Addendum No. 1

Issue Date: November 26, 2025

Project: Fitzgerald Creek WPCP Thermal Dryer Facility	Owner: Cherokee County Water & Sewerage Authority Cherokee County, Georgia
---	--

01-C-403

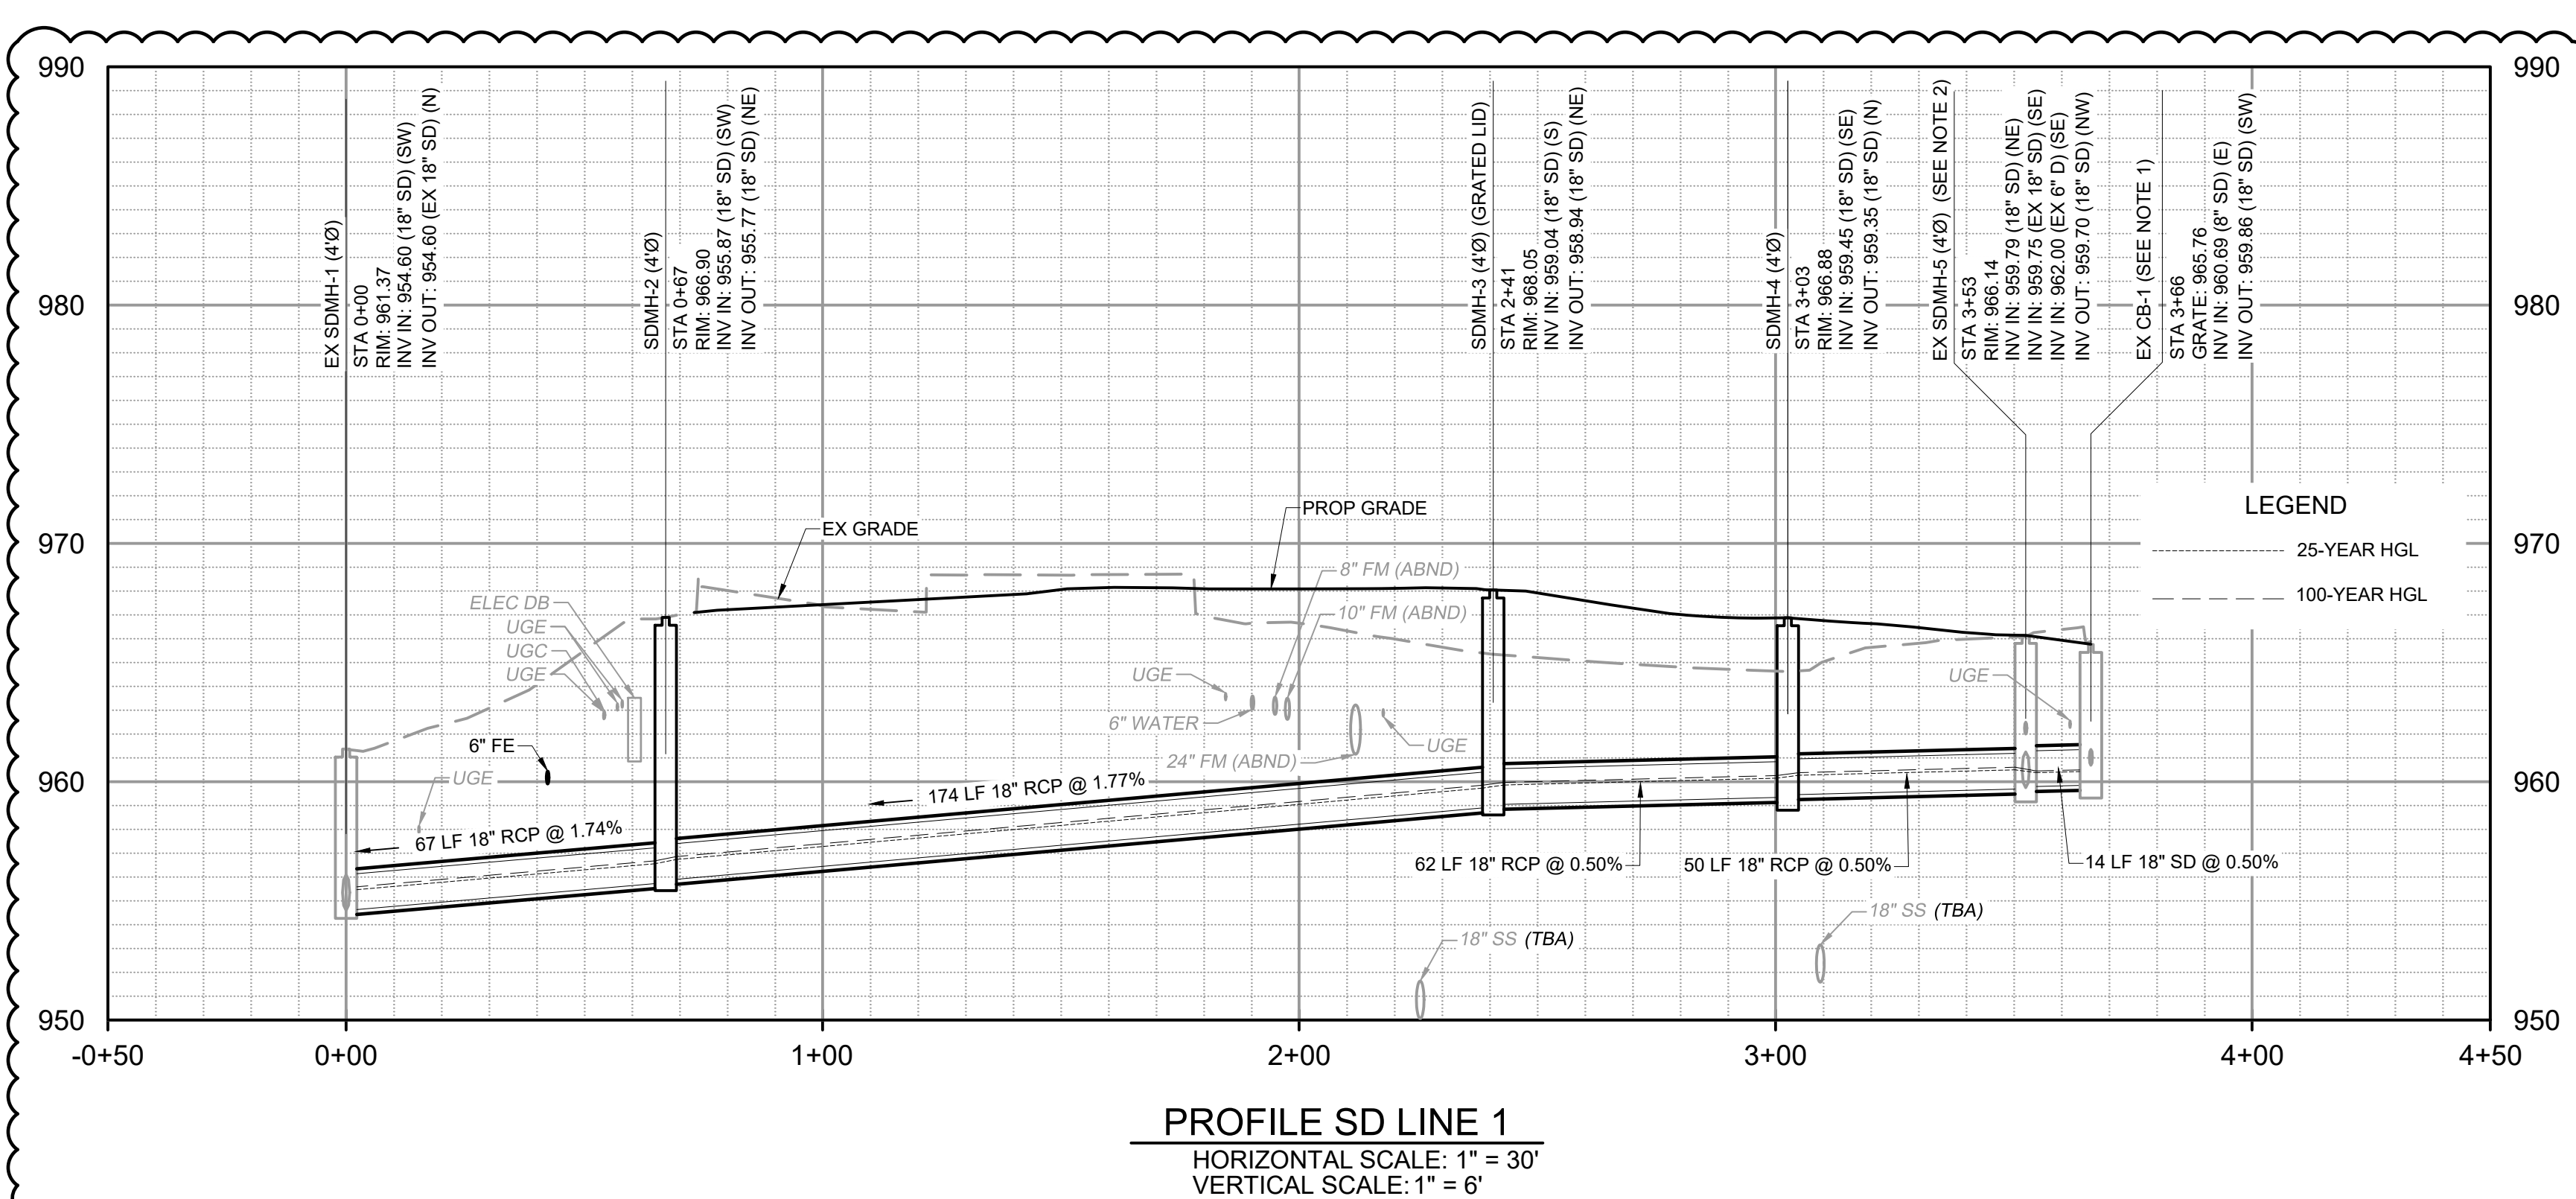
- REPLACE REPLACE Drawing 01-C-403 – SD Line 1 Plan and Profile in its entirety with Attachment No. 3 – Drawing 01-C-403 – SD Line 1 Plan and Profile (1 page).

CIVIL
SD LINE 2
PLAN AND PROFILE

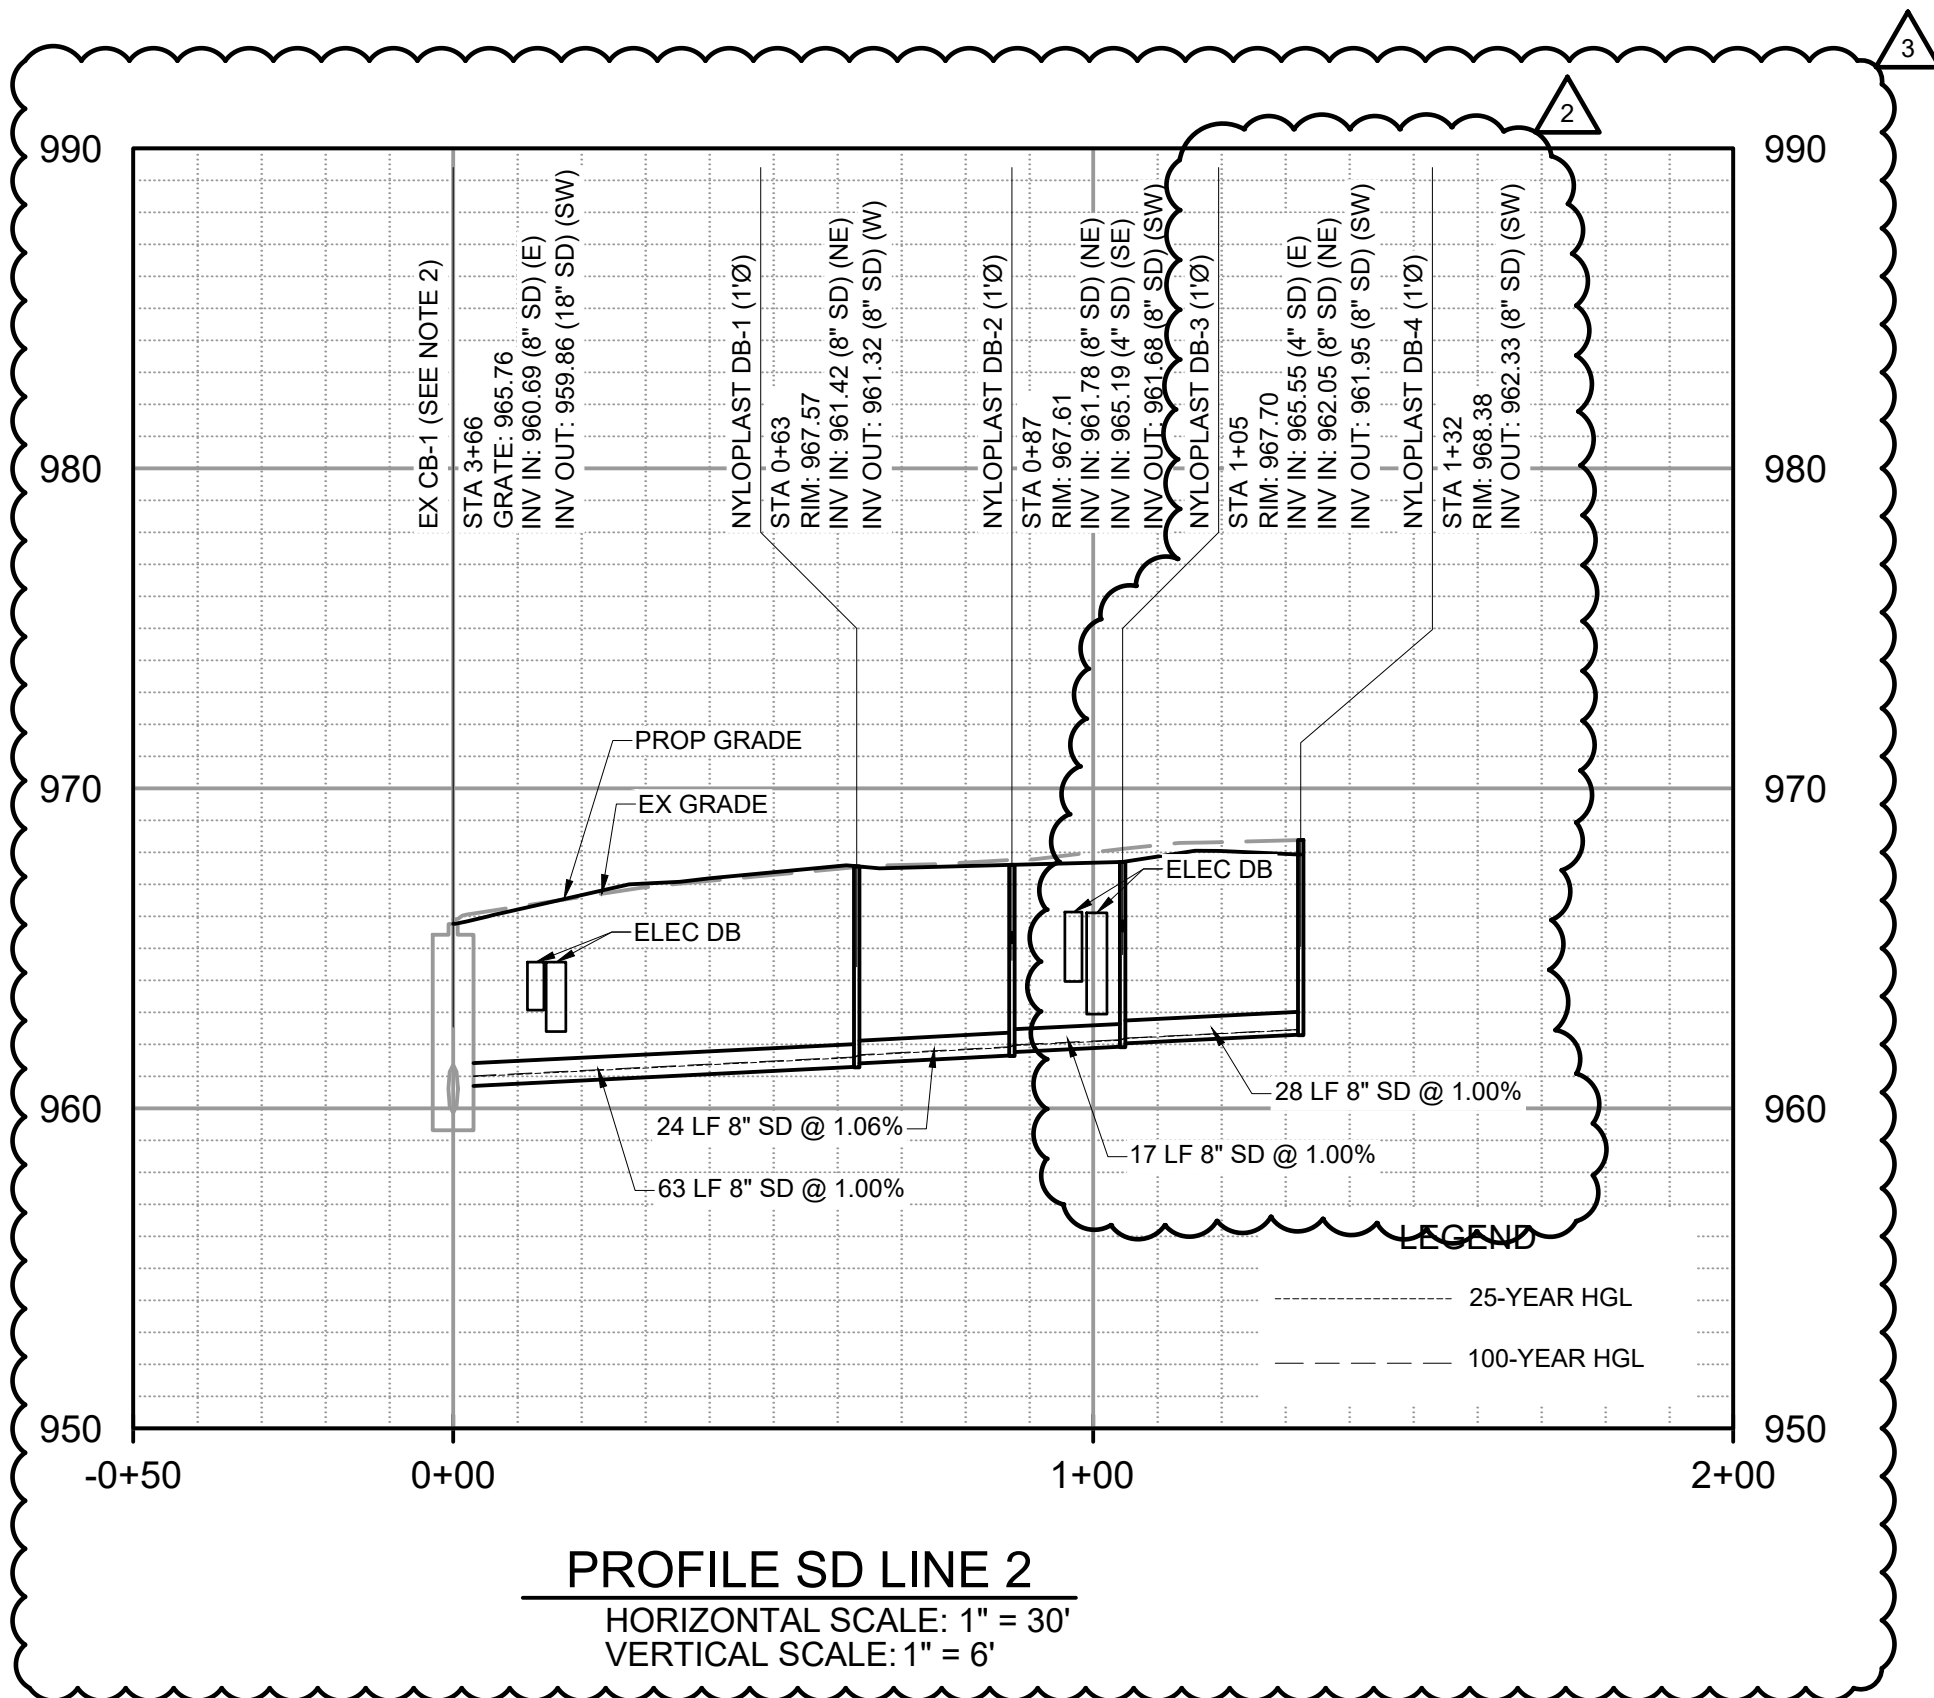
- REPLACE REPLACE Drawing 01-C-404 – SD Line 2 Plan and Profile in its entirety with Attachment No. 4 – Drawing 01-C-404 – SD Line 2 Plan and Profile (1 page).
